Virginia Department of Transportation
Thomas B. Vanpool, Sr. Engineer
Department of Planning
Comments / Responses
Potomac Interceptor, Fairfax County, VA
AMT File No. 109-301
March 26, 2010

County of Loudoun
Brian Fish, Planner
Department of Zoning Administration
Comments / Responses
Potomac Interceptor, Fairfax County, VA
AMT File No. 109-301
March 26, 2010

OVERVIEW PLAN

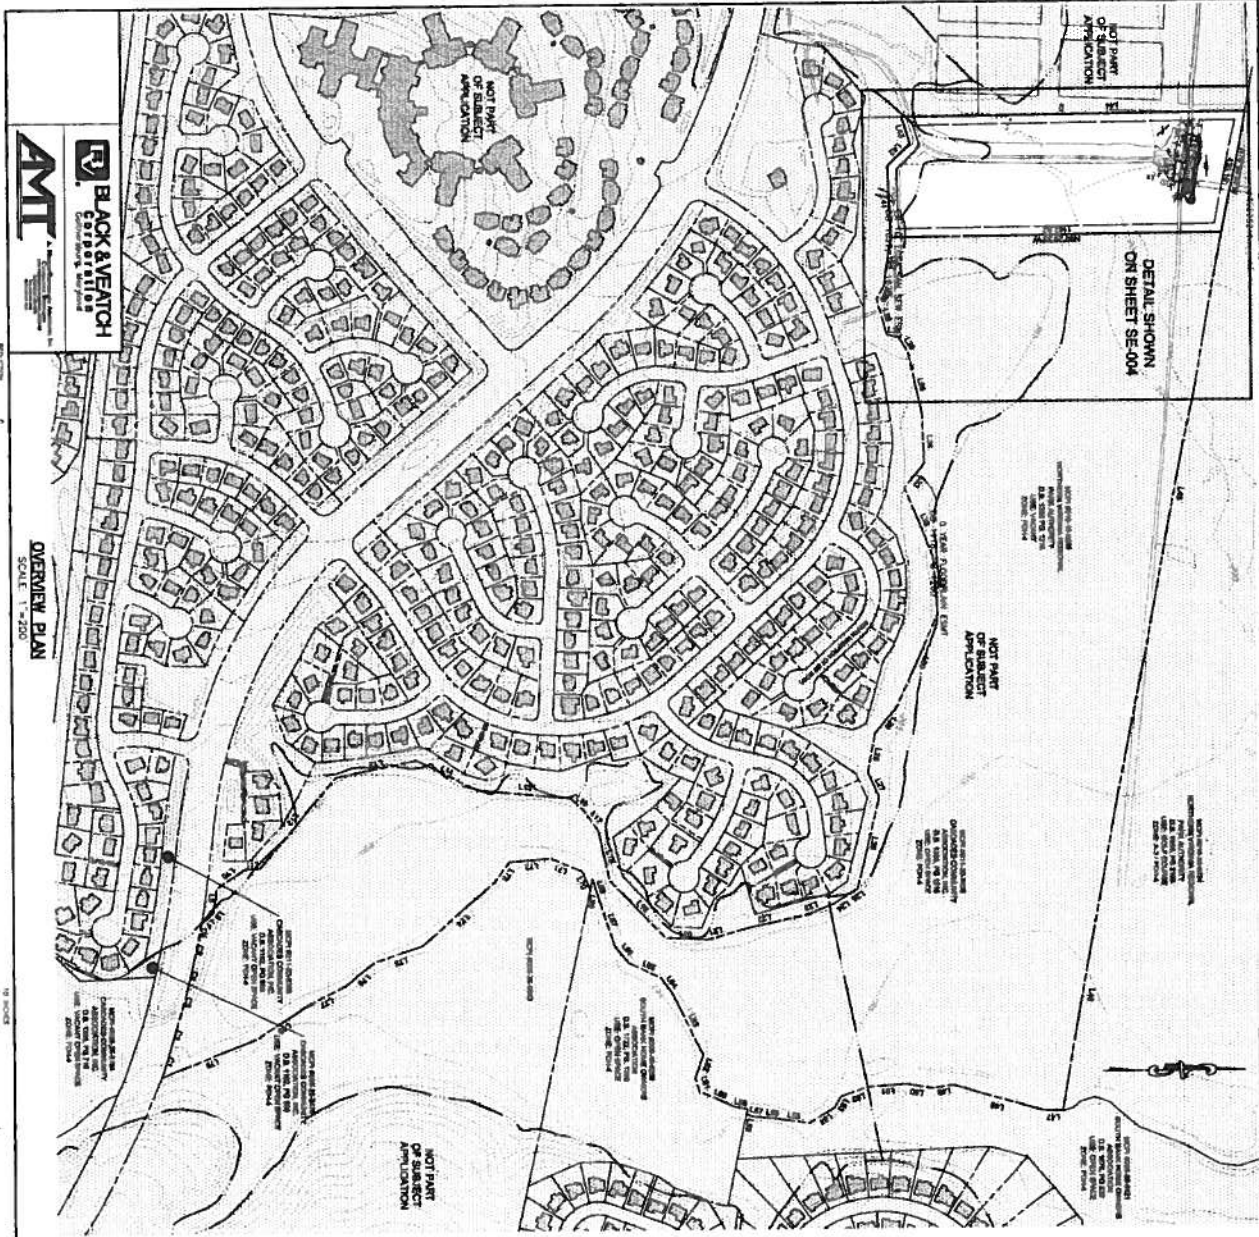
1. **Comment:** On Sheets 2-4, please revise the Plat Labels for MCPI #010-27-3227 and #010-17-4363 under "Use" to *Potomack Lakes Sportsplex*.

Comment: Sheets 2-4 do not show the outlines of the baseball/softball and/or soccer fields at the Sportsplex. Please provide information on the distance between the proposed facility and the closest soccer fields.

RESPONSE: Additional use information listed as Potomack Lakes Sportsplex added, see sheets SE-002 thru SE-004

RESPONSE: Sportsplex ball field outlines have been added to sheets SE-002 thru SE-004.
